CITY PLAN COMMISSION

FILE NUMBER: S245-114

REQUEST: An application to replat a 0.24-acre (10,381-square foot) tract of land containing part of Lot 9 in City Block 1/4340 to create one lot on property located on Ann Arbor Avenue, west of Biglow Avenue.

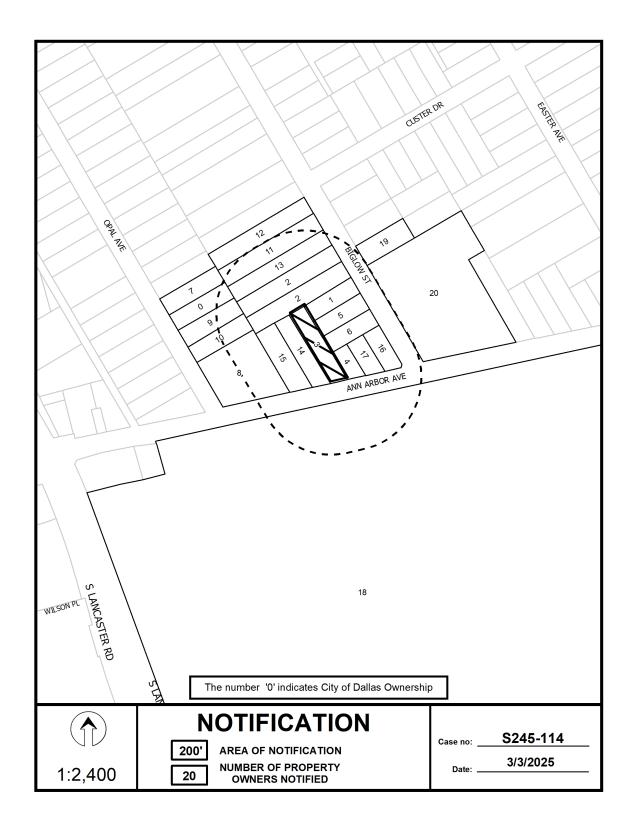
- 21. Prior to final plat, compliance with City's Street lighting standards including illumination standards, material, installation, and activation per Street Design Manual.
- 22. On the final plat, change "East Ann Arbor Avenue (FKA Dartmouth)" to "Ann Arbor Avenue (FKA Dartmouth Avenue)".
- 23. On the final plat, change "Biglow Avenue (FKA Castle)" to "Biglow Street (FKA Castle Street)".
- 24. On the final plat, identify the property as Lot 9A in City Block 1/4340.
